Re: DEP File No. 1110099-002-AC (PSD-FL-304)  
Midway Energy Center  
Three Simple Cycle Combustion Turbines

DEP File No. 1110099-002-AC (PSD-305)  
Midway Energy Center, Units 1 - 3  
St. Lucie County

**FINAL DETERMINATION**  
**File No. 1110099-002-AC (PSD-FL-305)**  
**MIDWAY DEVELOPMENT COMPANY, L.L.C.**  
**510 MW SIMPLE CYCLE FACILITY**

**Figure 2 - DLN2.6 Fuel Nozzle Arrangement**

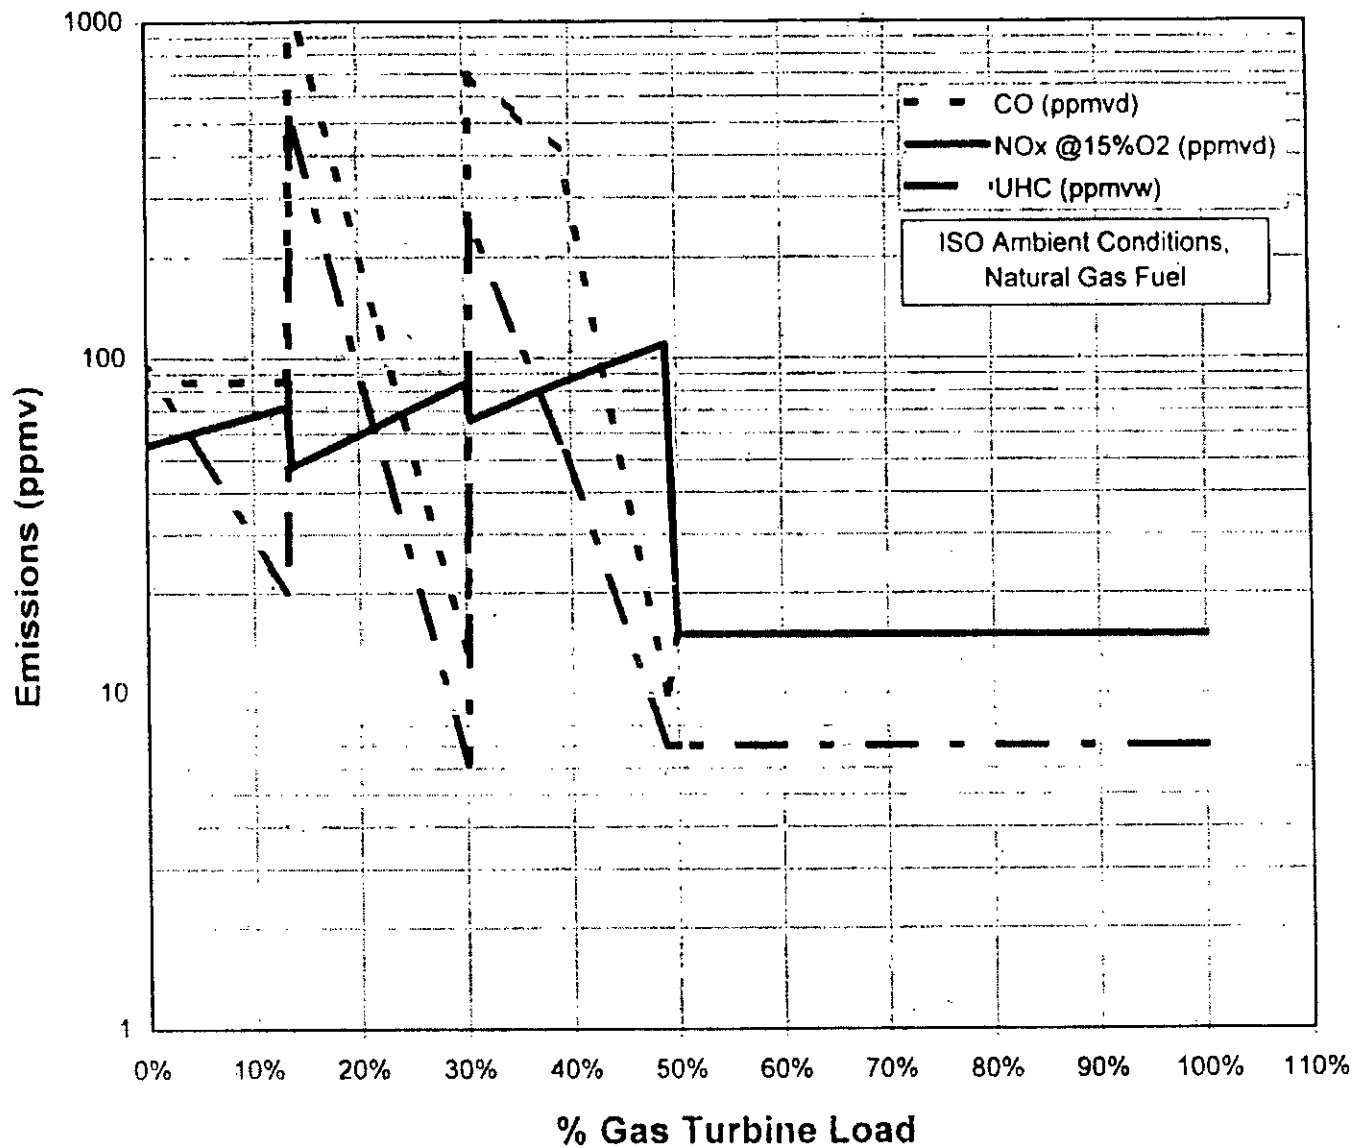
- The Department prefers not to set a 24-hour average limit that includes start-up emissions for a peaking unit. There will be a very short period during start-up when emissions might actually exceed 100 ppmvd (see Figure 2). Such periods can probably be absorbed into an emissions limit with a long-term averaging time for continuous duty. It would be much more difficult for an intermittent duty unit that might run only a few continuous hours on occasion.
